Attachment 3

MARKED-UP TECHNICAL SPECIFICATION PAGES

8812070189 881129
PDR ADOCK 05000275
P PDC

FIGURE 3.2-3a
 RCS TOTAL FLOW RATE VERSUS R (UNIT 1 *cycle 4 and after*)

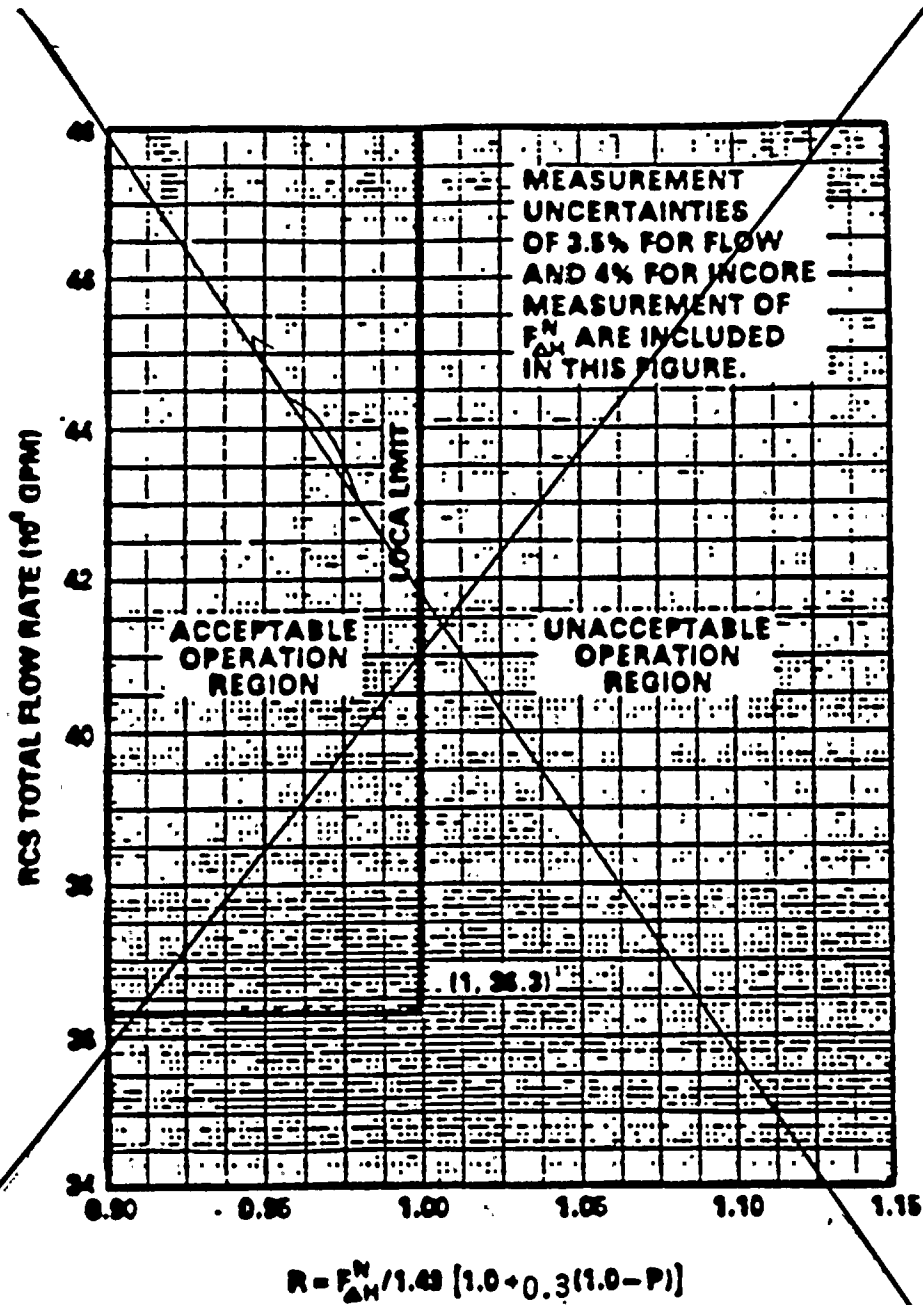
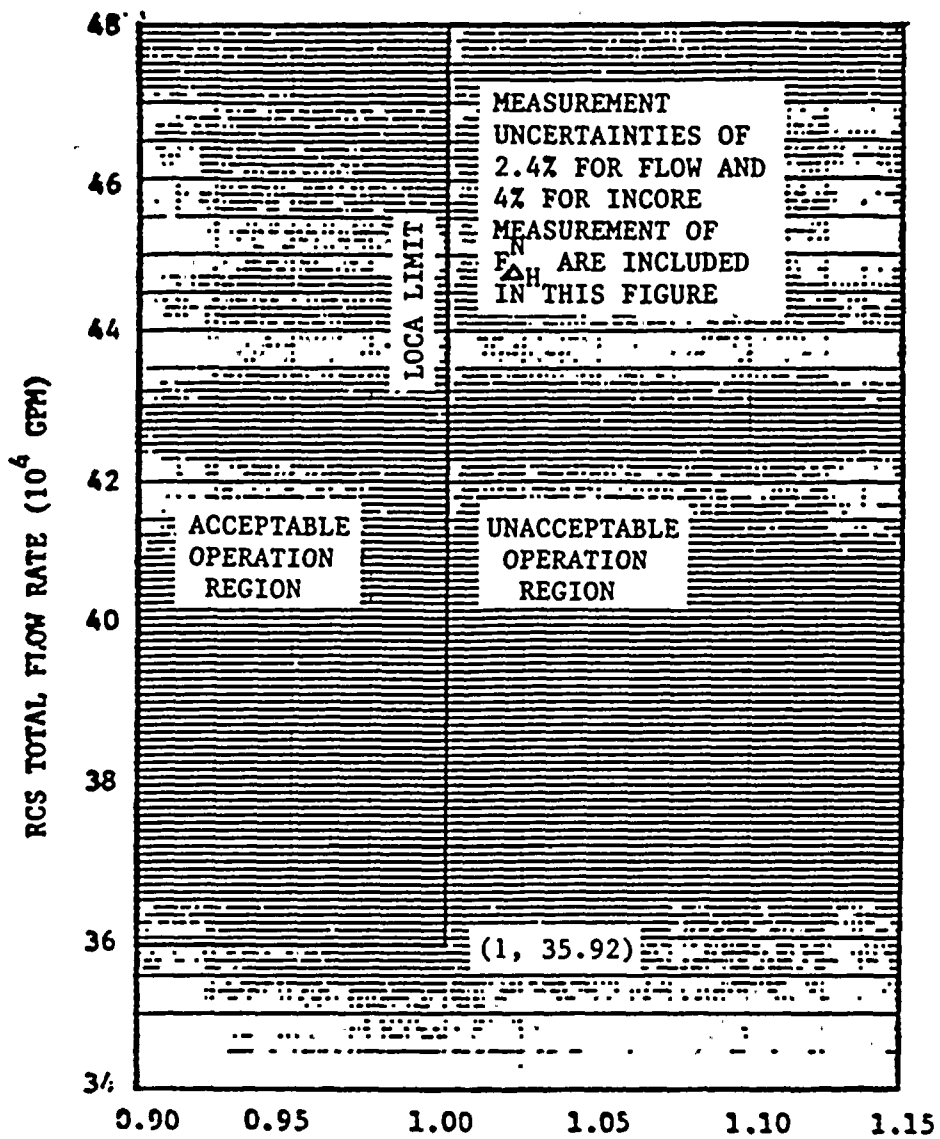
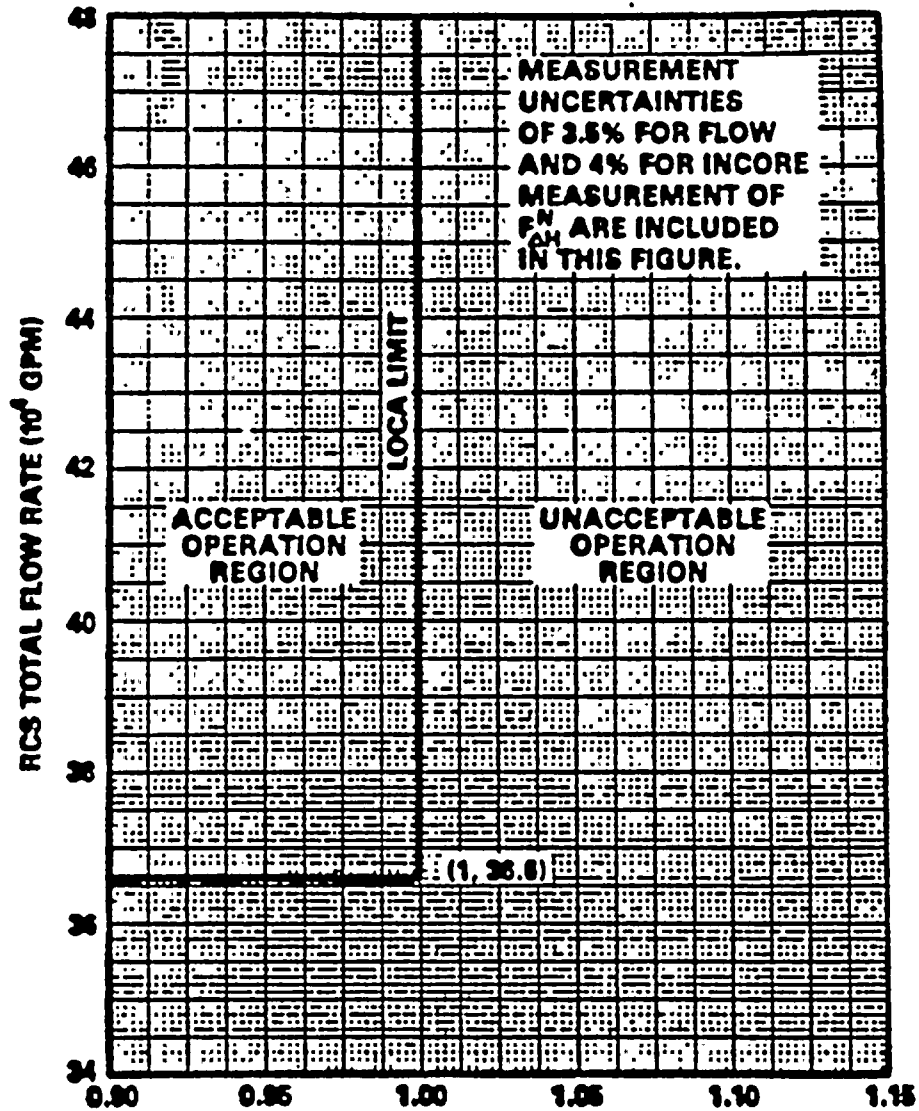
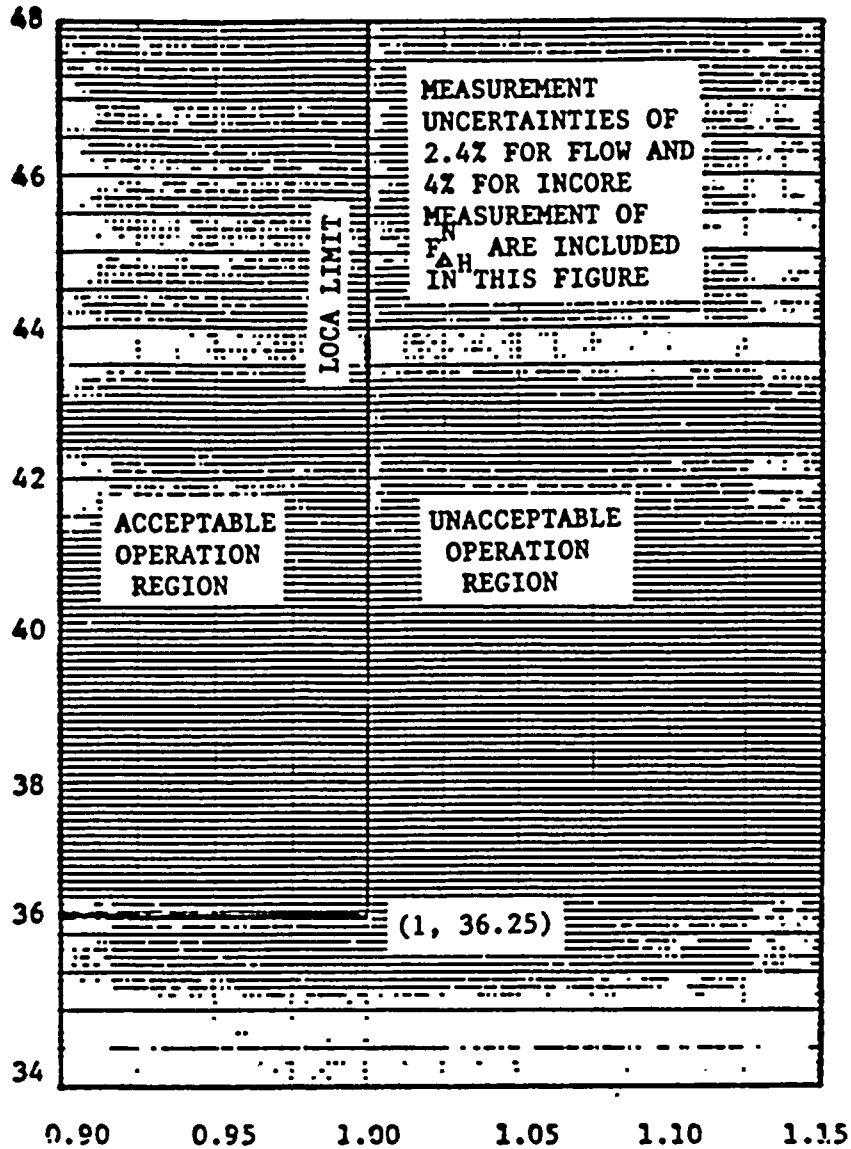
3.2.3 The combination of indicated Reactor Coolant System (RCS) total flow rate and R shall be maintained within the region of allowable operation shown on Figure 3.2-3a for Unit 1 and Figure 3.2-3b for Unit 2 for four loop operation.
Cycle 4 and after,
Cycle 3, and Figure 3.2-3c for Unit 2 Cycle 4 and after

and Figure 3.2-3c for Unit 2 Cycle 4 and after includes measurement uncertainties of 2.4% for flow.

With the combination of RCS total flow rate and R outside the region of acceptable operation shown on Figure 3.2-3a for Unit 1, and, Figure 3.2-3b for Unit 2, *Cycle 3 and Figure 3.2-3c for Unit 2 Cycle 4 and after*

REPLACE
